## Stage 03: Modification Report

National Electricity Transmission System Security  
and Quality of Supply Standards (NETS SQSS)

# GSR014: Review of Requirement of Onshore Connection Facilities for Offshore Wind Farm Connections

03 Modification  
Report

Figure 1. Schematic diagram of the offshore transmission system designs considered.

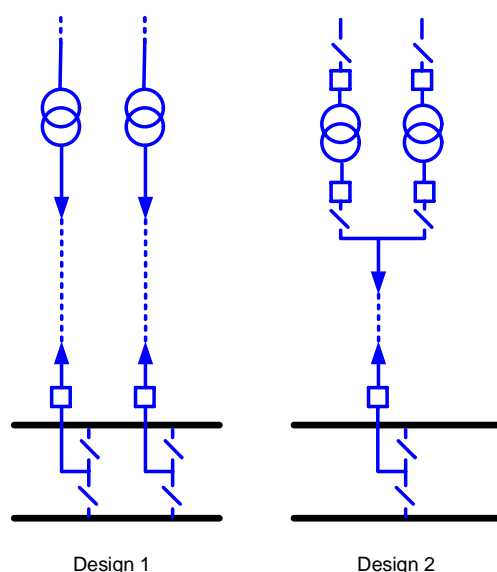
1. The SQSS section 7.13.1.1 refers to wind farms with GEP capacity of 120MW or above. However, the study compares only wind farms with capacity at GEP of 250MW or above. The conclusion that a configuration with a double bay is the best solution for wind farms of sizes between 120 and 250MW cannot be drawn based upon the presented calculations, also given the fact that the presented results show a decrease in benefits of having two bays when the wind farm decreases its capacity.

**Response:** As you may remember from being a member of the Workgroup, it was clearly stated and agreed among the Workgroup Members that Design 3 was not considered to be a compliant design and as such was not subject to comparison with the classical design.

**Response:** It was agreed in the scope of the Workgroup to analyse a range of wind farm sizes between 120MW and 1GW as per the recommendation from the CBA used for the offshore standards previously. With increasing wind farm output, the difference between 50m and 700m will increase. In the case of 120MW the difference between 50m and 700m for GIS is smaller as the operational costs in those cases due to the failure or maintenance of the offshore assets will be smaller.
